The Commission has issued the enclosed Amendment No. 59 to Provisional Operating License No. DPR-19 for Dresden Station Unit 2 and Amendment Nos. 52, 70, and 64 to Facility Operating License Nos. DPR-25, DPR-29, and DPR-30 for Dresden Station Unit 3 and Quad Cities Station Units 1 and 2, respectively. The amendments are in response to your letter of November 1, 1979.

The amendments will allow reactor power ascension to proceed along a modified power/flow line. This will facilitate adherence to procedures designed to reduce fuel pellet-clad interaction.

SAFETY EVALUATION BY THE OFFICE OF NUCLEAR REACTOR REGULATION

SUPPORTING AMENDMENT NO. 59 TO PROVISIONAL OPERATING LICENSE NO. DPR-19

FIGURE 2.1-3
(SCHEMATIC)

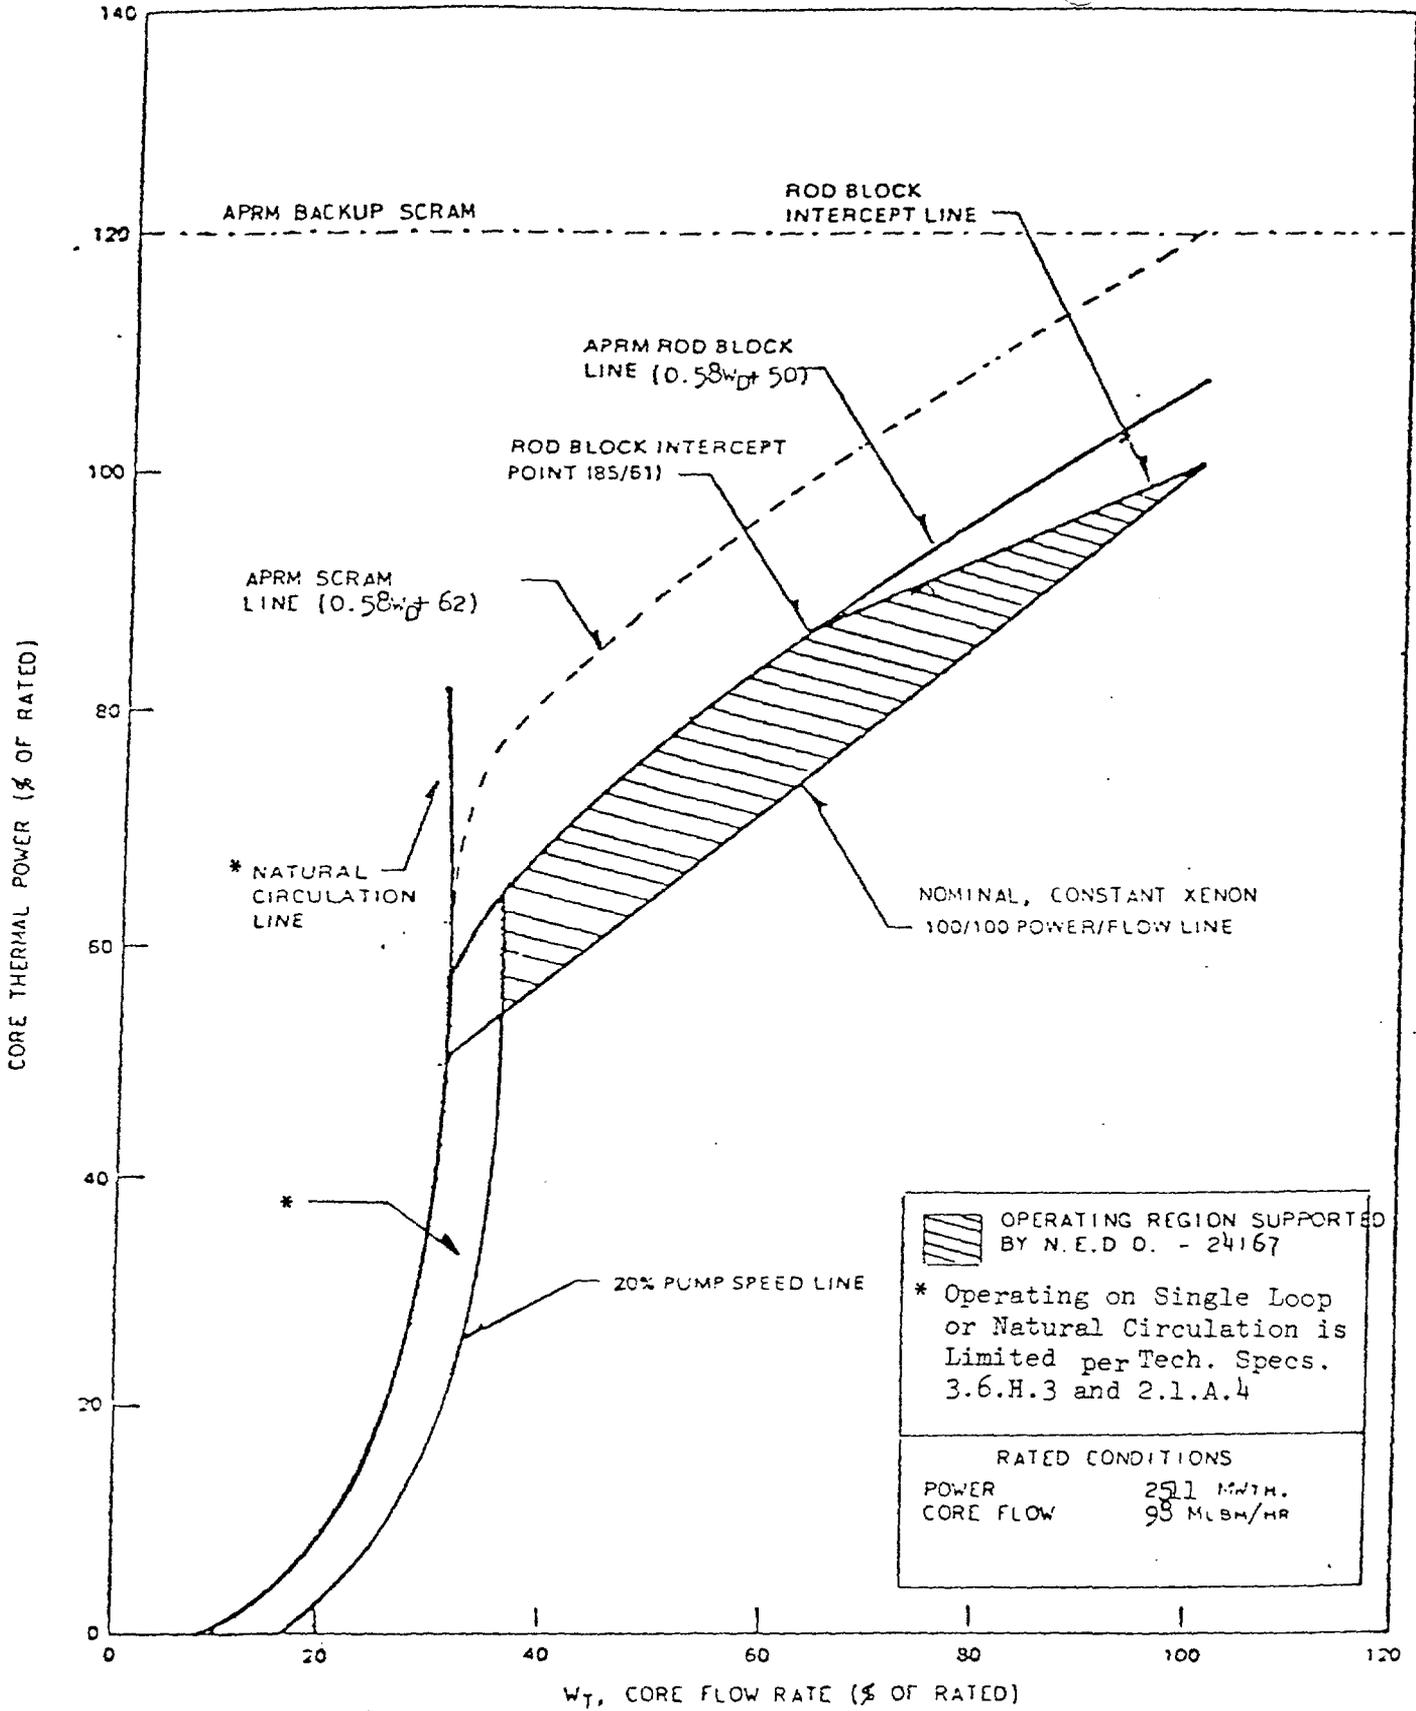
Replace
